**SYDNEY NORTH PLANNING PANEL
ASSESSMENT REPORT**

SNPP No:	2017SNH037
DA No:	327/15/5
ADDRESS:	101-111 Willoughby Road, CROWS NEST
LGA:	North Sydney Council
PROPOSED DEVELOPMENT:	To modify consent DA327/15 for a 4- to 6-storey mixed use development with regard to new commercial space on mezzanine and upper ground floor, converting balconies to wintergardens, façade changes, level changes, unit layout changes and carpark modifications
APPLICANT:	Ionic Management Pty Ltd
OWNER(S):	CN Plaza No.1 Pty Ltd
REPORT BY:	Susanna Cheng, Senior Assessment Officer

PROPOSAL: To modify consent DA327/15 for 4- to 6-storey mixed use development with regard to new commercial space on mezzanine and upper ground floor, converting balconies to wintergardens, façade changes, level changes, unit layout changes and carpark modifications

DATE OF REPORT: 24 July 2017

Figure 1 – Photomontage of approved & proposed development

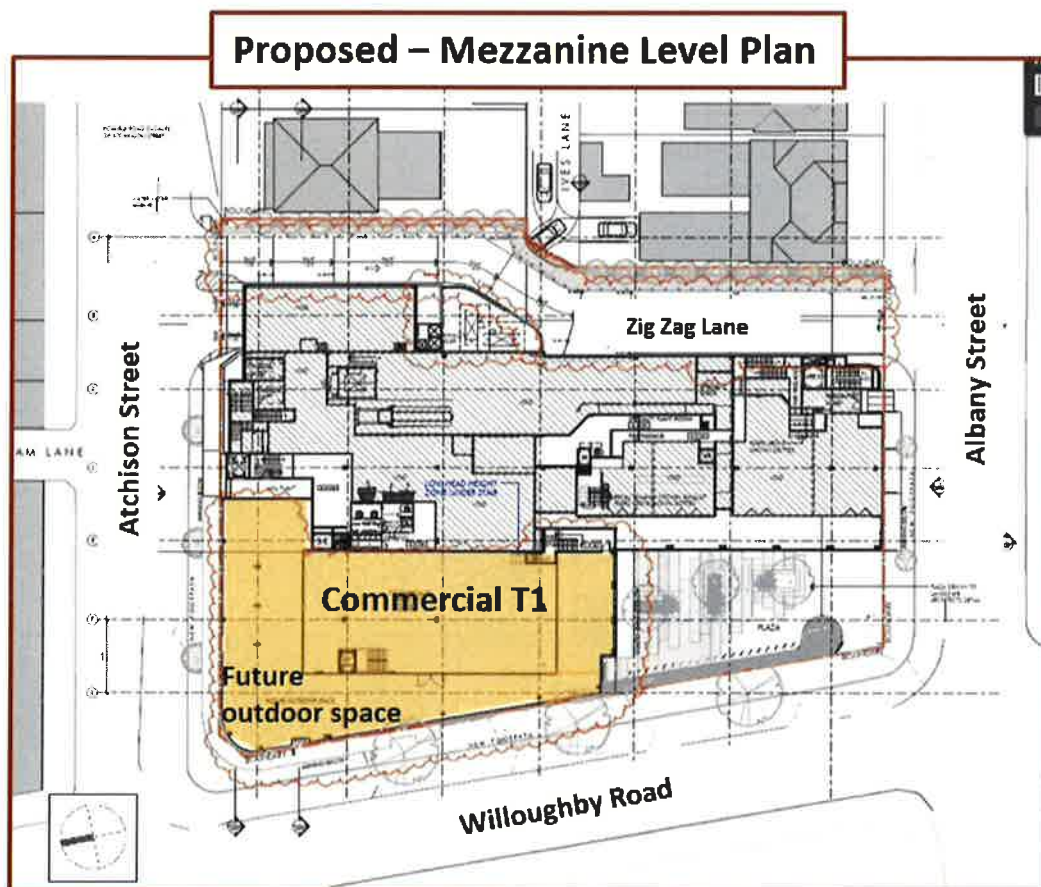
The Panel queried the extent of Coles signage at the corner and was advised that the smaller sign as per the elevation was correct rather than the montage showing an excessive signage.

Figure 2 – Proposed modifications

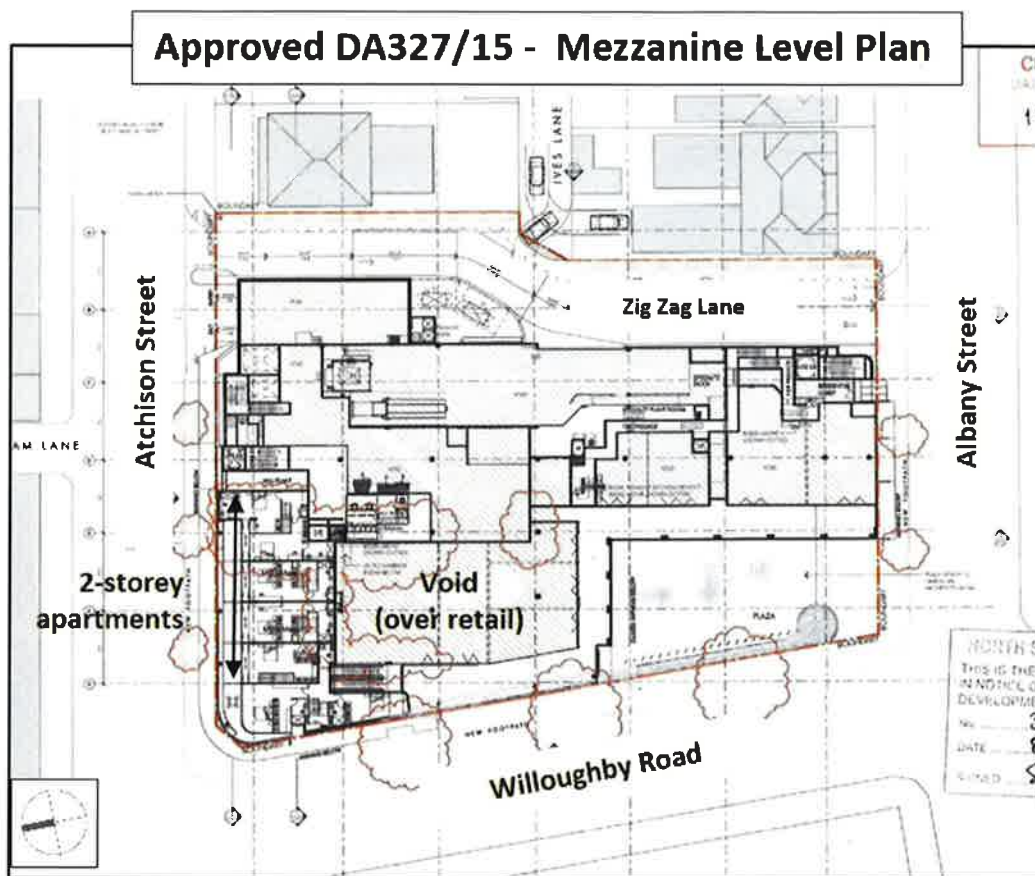
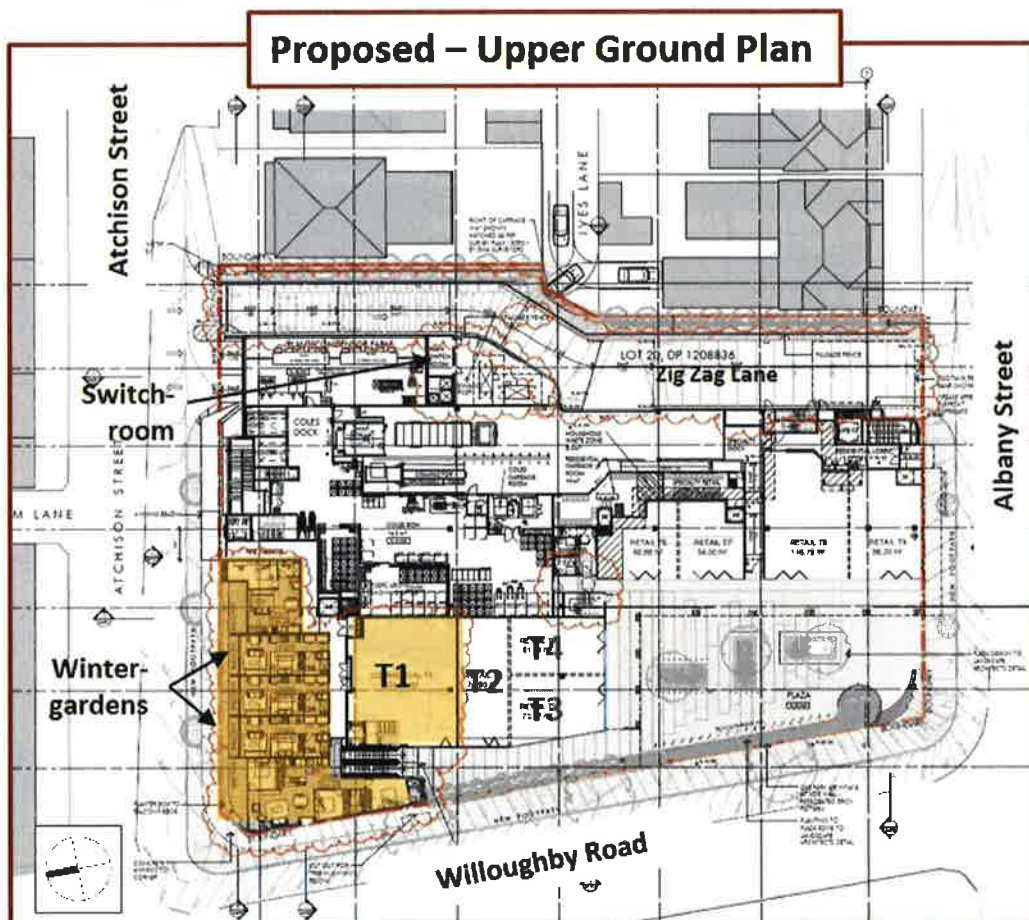
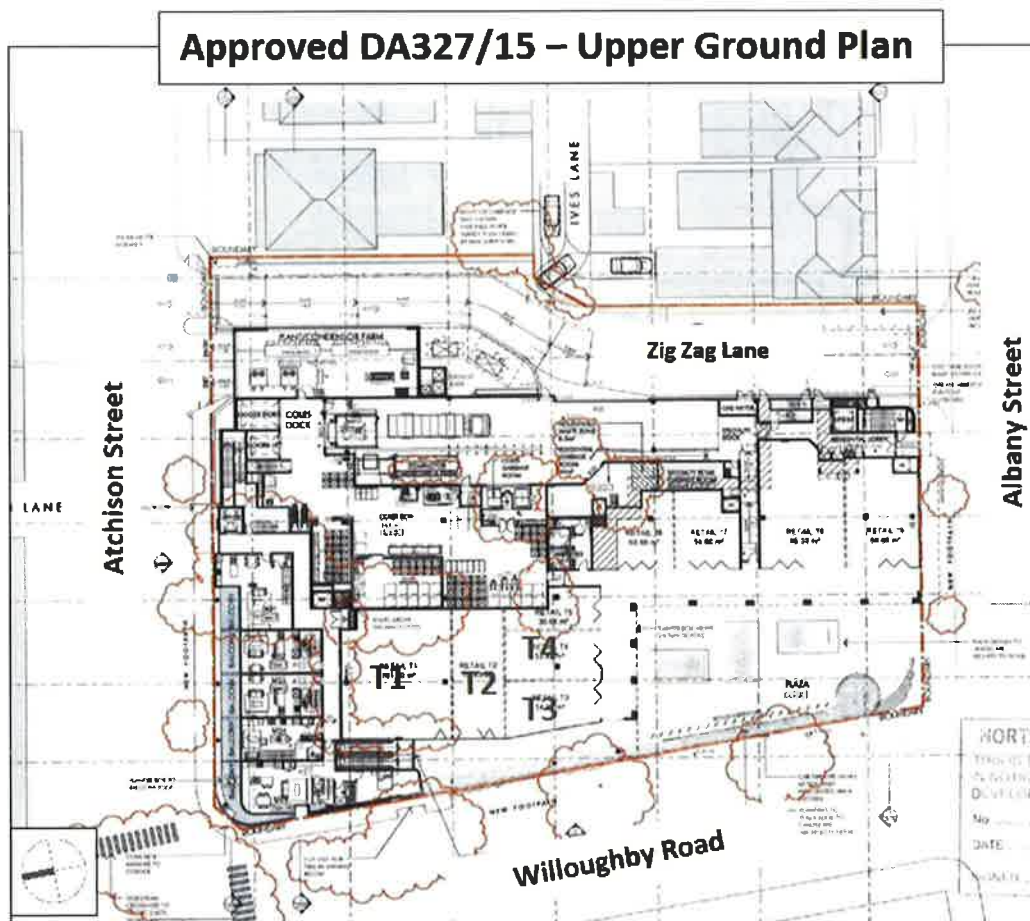
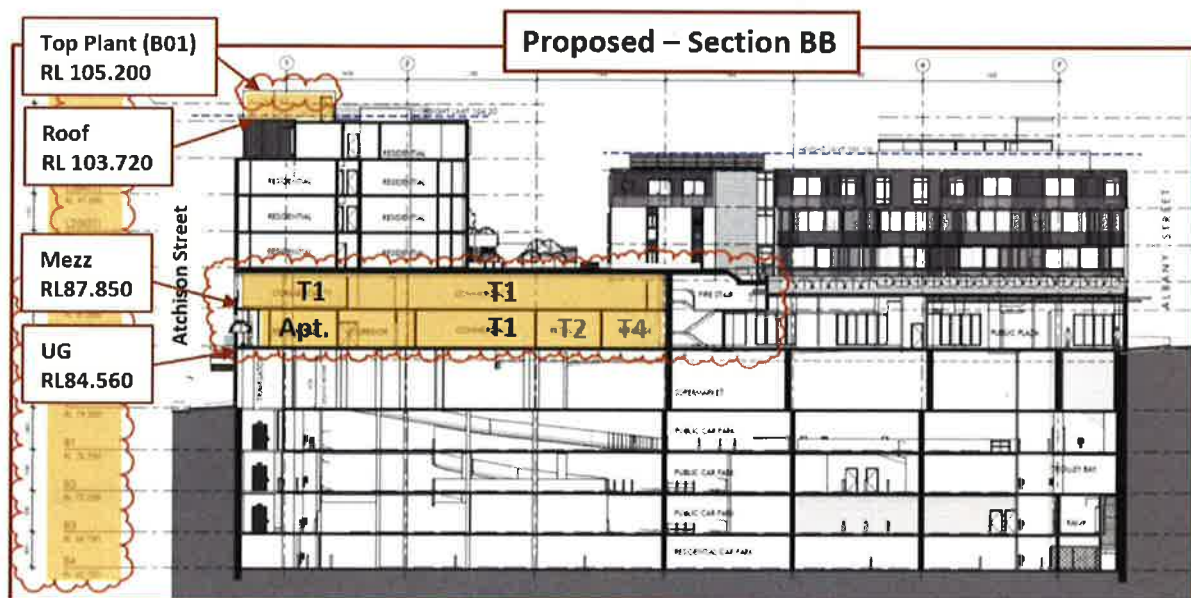
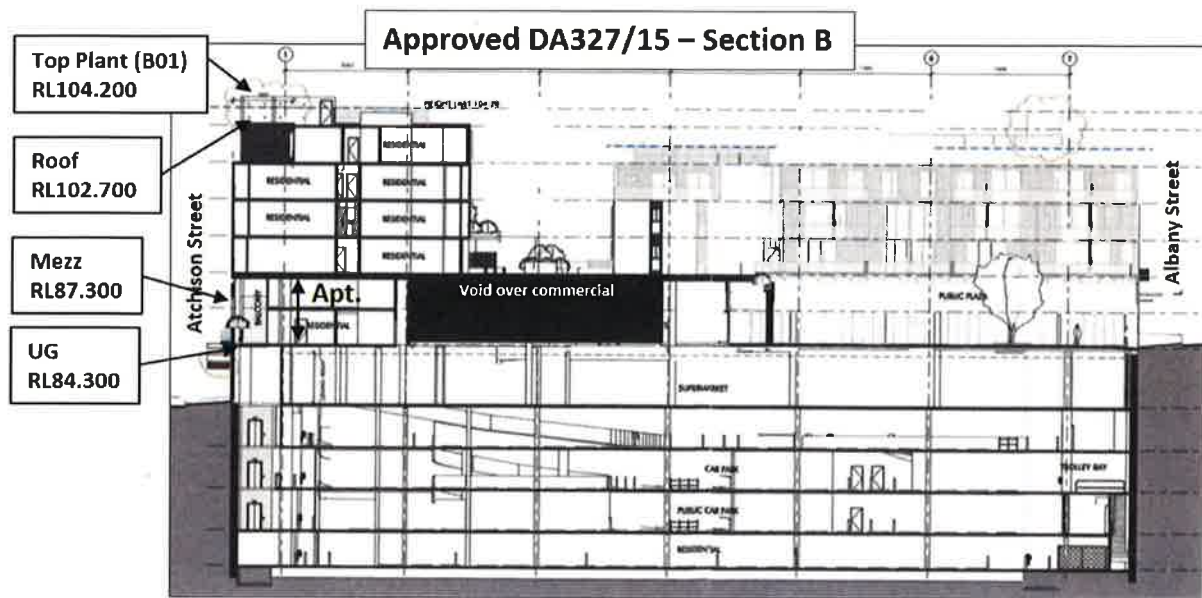
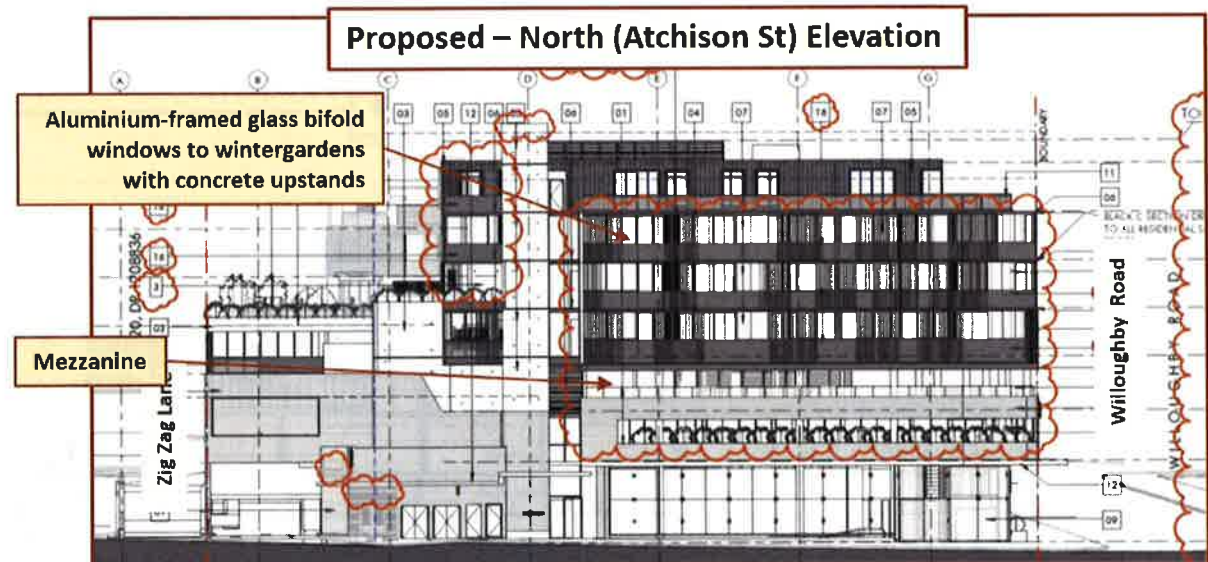
Key modifications are highlighted in **Figure 2** on the following pages.

Figure 6 – Proposed height breaches at top of plant & lift overrun & stair of Building 01

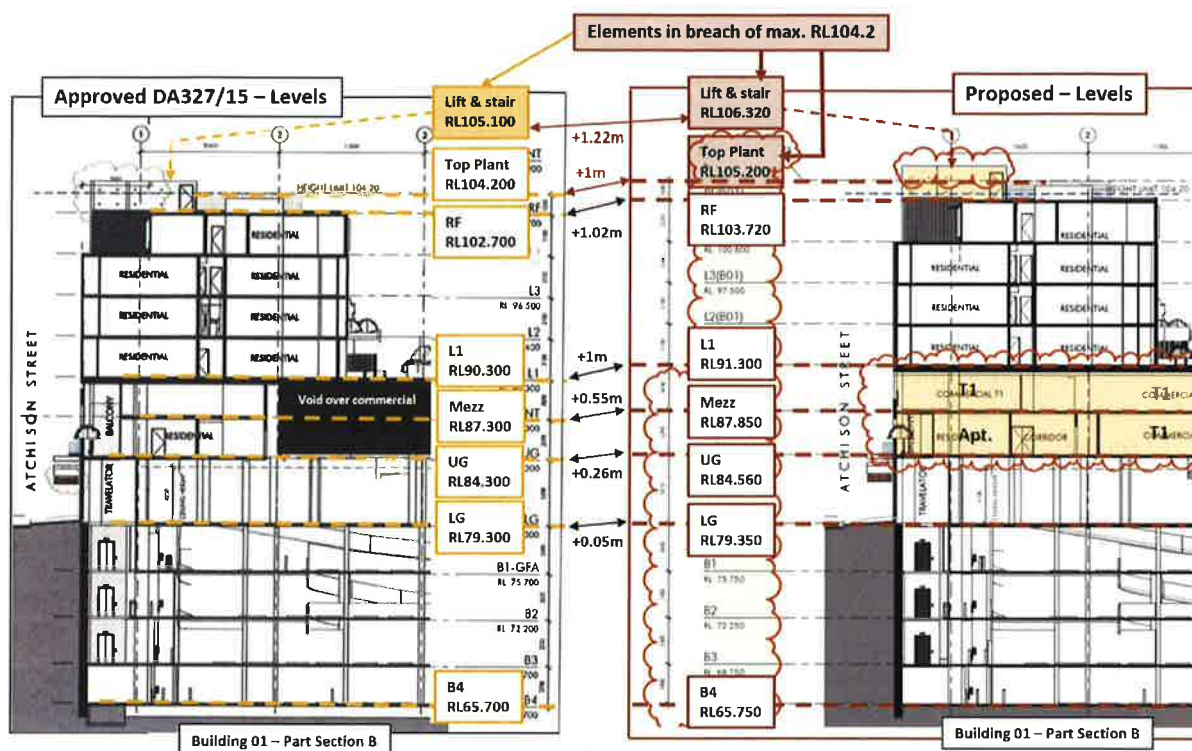
The height of the lift overrun and stair of Building 01, as approved, exceeds the maximum height of RL104.2. The development as proposed to be modified will give rise to additional breaches in the location of the lift overrun and stair, as well as to the top of roof plant, as detailed in the table below.

Max.RL104.2 (Building 01)	Approved		Proposed change	Proposed	
	Height	Variation		Height	Variation
Lift overrun & stair	RL105.100	+0.9m (0.9%)	+ 1.22m (+1.17%)	RL106.320	2.12m (2%)
Top of Plant	RL104.200	(Complies)	+ 1m (0.96%)	RL105.200	1m (0.96%)

The additional breaches of the height control are associated with internal floor level changes that would allow for the insertion of additional commercial space within Building 01 while maintaining a building envelope that remains substantively compliant with the height control. There is no public benefit in maintaining the control on the site for the proposed additional variations which are limited to ancillary building elements. Compliance with the height control is unnecessary and unreasonable in this instance as the proposal satisfies the objectives of the control despite the variations.

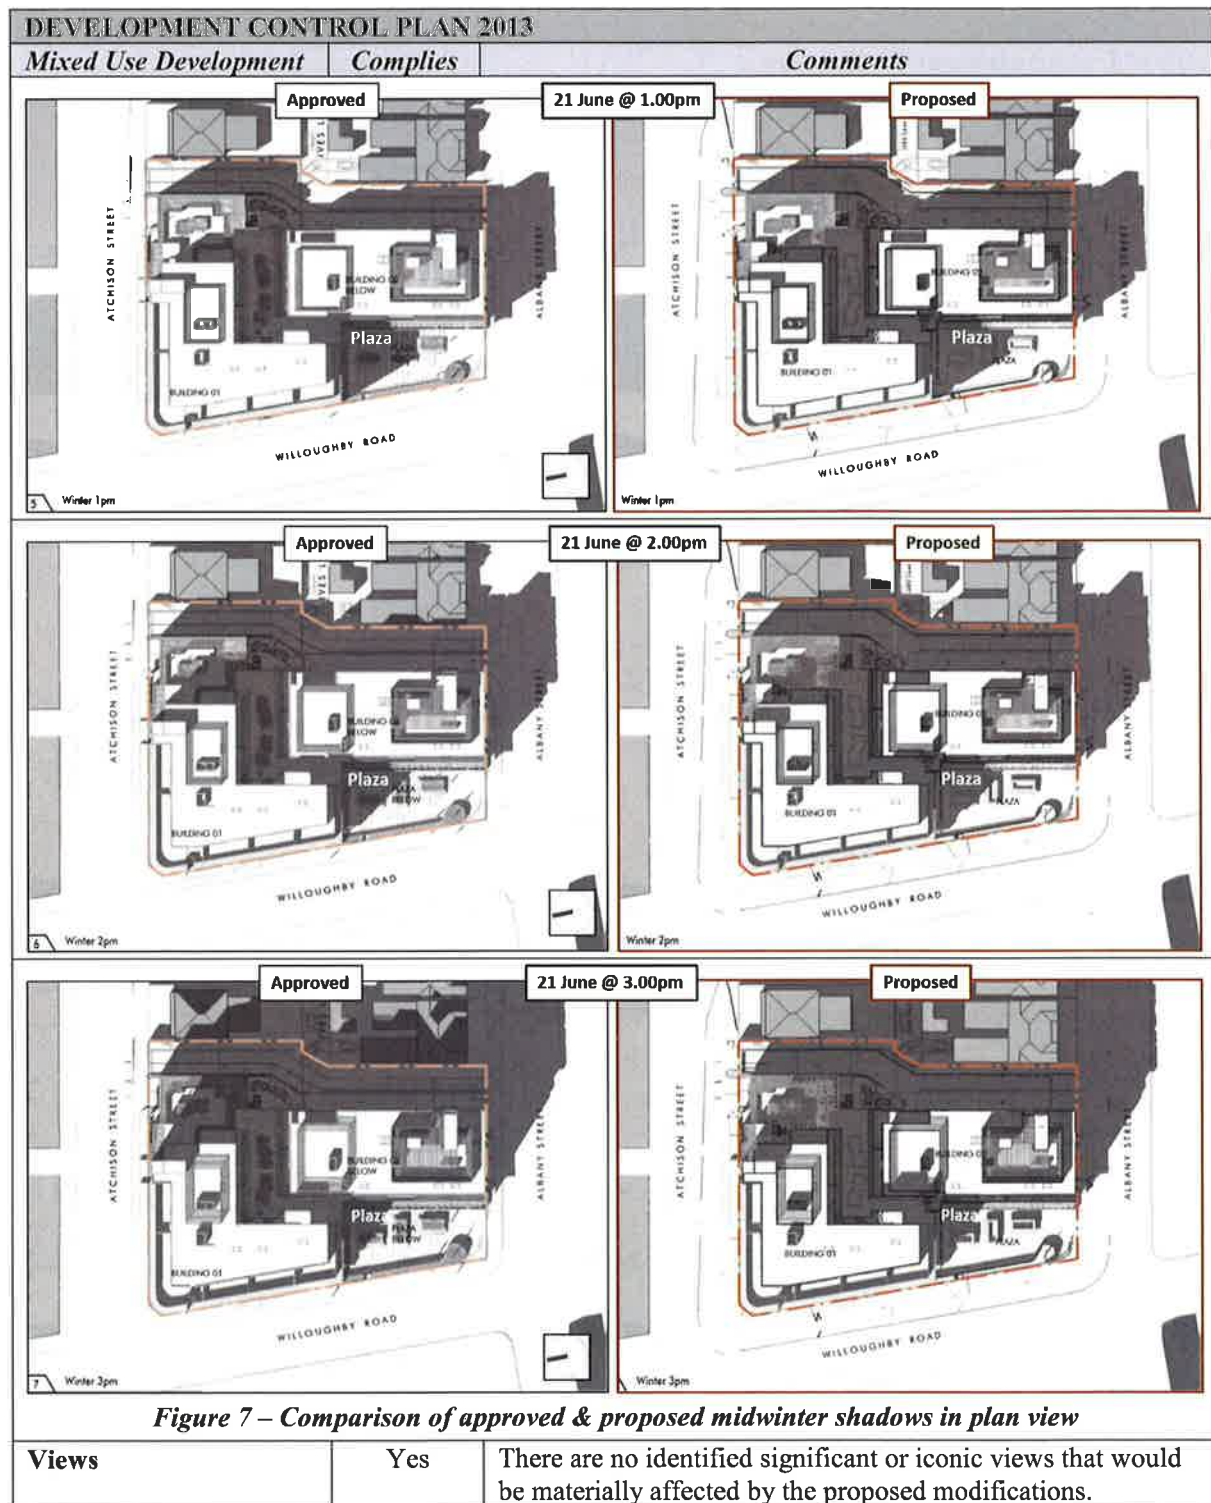
Wind speed	Yes	The overall building envelope as proposed to be amended and any wind effects would be comparable to the approved development.
Reflectivity	Yes	The proposed facades will provide for a balance of solid to void on all facades, including recessed winter gardens; a standard condition is recommended to ensure no nuisance glare from glazing.
Artificial illumination	Yes	(No change)
Awnings	Yes	No change is proposed to the awnings as approved on the Willoughby Road, and Atchison & Albany Street frontages.
Solar access	Yes	The proposed modifications do not give rise to any significant additional shadow impacts compared to the approved development, in particular, in relation to the approved public plaza on the south western corner of the site, as illustrated in the submitted shadow diagrams in Figure 7 .

Figure 8 – Eastern wintergardens set back 10m from boundary across Zig Zag Lane

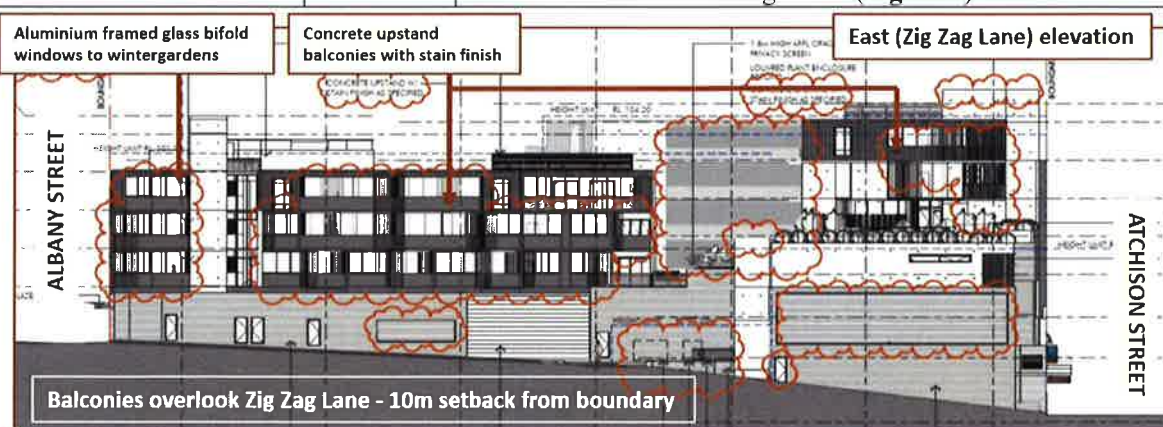
The Panel raised no objection to the modification of condition requiring additional privacy treatment to the east facing apartments on the basis of the 10m separation being sufficient.

DEVELOPMENT CONTROL PLAN 2013		
Mixed Use Development	Complies	Comments
Acoustic privacy	Yes	<p>The proposed conversion of various balconies to wintergardens will generally reduce any noise impacts on adjoining development, including dwellings to the east separated by Zig Zag Lane as per the approved setback.</p> <p>The internal floor-to-floor height of 3.29m between the Upper Ground & Mezzanine levels provides for acoustic insulation between the proposed apartments on the Upper Ground Level and adjoining T1 commercial tenancy; a condition is recommended to ensure acoustic attenuation is provided for all residential units.</p>
Vibration	Yes	The proposed modifications do not result in any greater exposure of apartment units to road noise and vibration.
Visual privacy	Yes	The proposed modifications will adequately provide for visual privacy; in particular, on the eastern elevation adjoining dwellings, by virtue of the 10m setback across Zig Zag Lane (as approved) and provision of concrete balcony upstands and bi-fold windows to wintergardens (Figure 8).

Figure 9 – Approved supermarket, residential and retail dock & waste storage areas

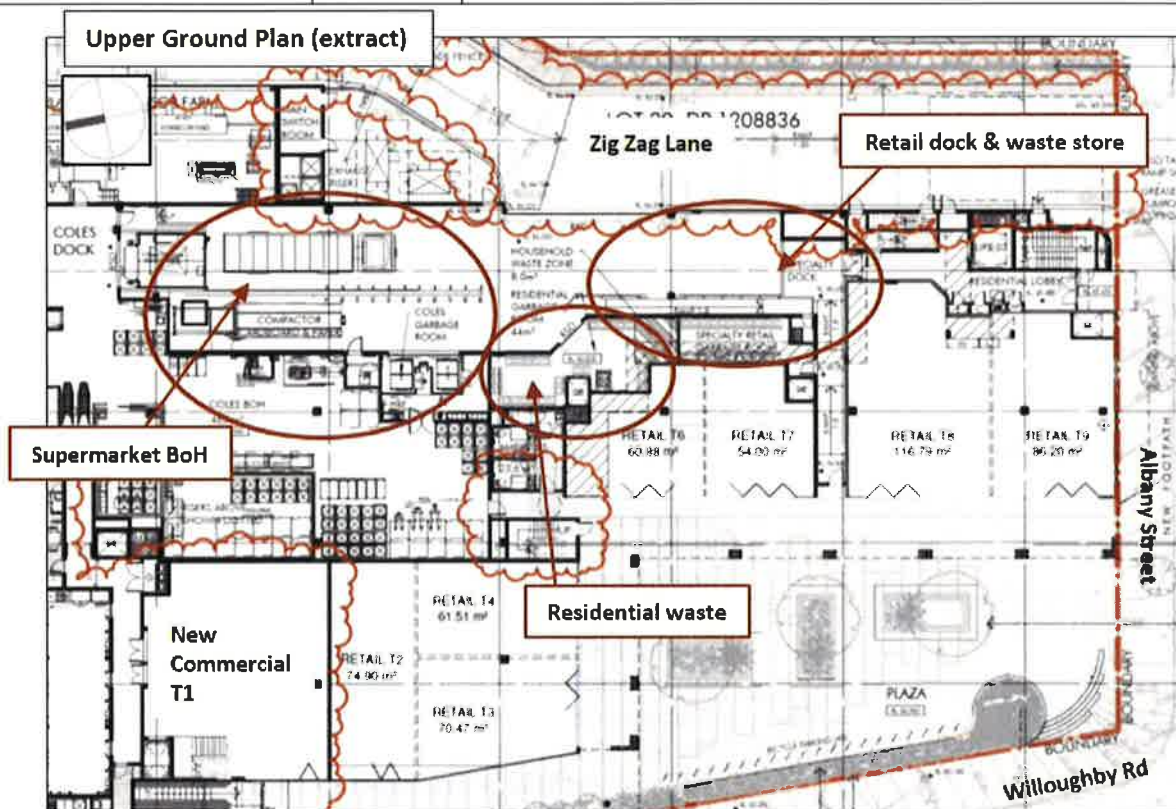
DEVELOPMENT CONTROL PLAN 2013		
Mixed Use Development	Complies	Comments
Garbage storage	Yes	<p>The submitted Waste Management Plan dated February 2017 by Waste Audit and received by Council on 9/3/17 indicates that waste storage will be adequately provided for in relation to the residential and commercial components of the development as proposed to be modified; in particular:</p> <ul style="list-style-type: none"> The proposed allocation of 44m² for residential waste & recycling bins exceeds the minimum allocation of 34.06m²; and The proposed allocation of 22.3m² for retail/commercial uses exceeds the minimum allocation by 18.79m². <p>The approved waste storage for residential and non-residential uses is shown in Figure 9; a condition is recommended to clarify that the “Specialty retail” dock and waste storage areas as notated on the approved plans are to be made available for use by the proposed new Commercial tenancy T1, to clarify the consent.</p>
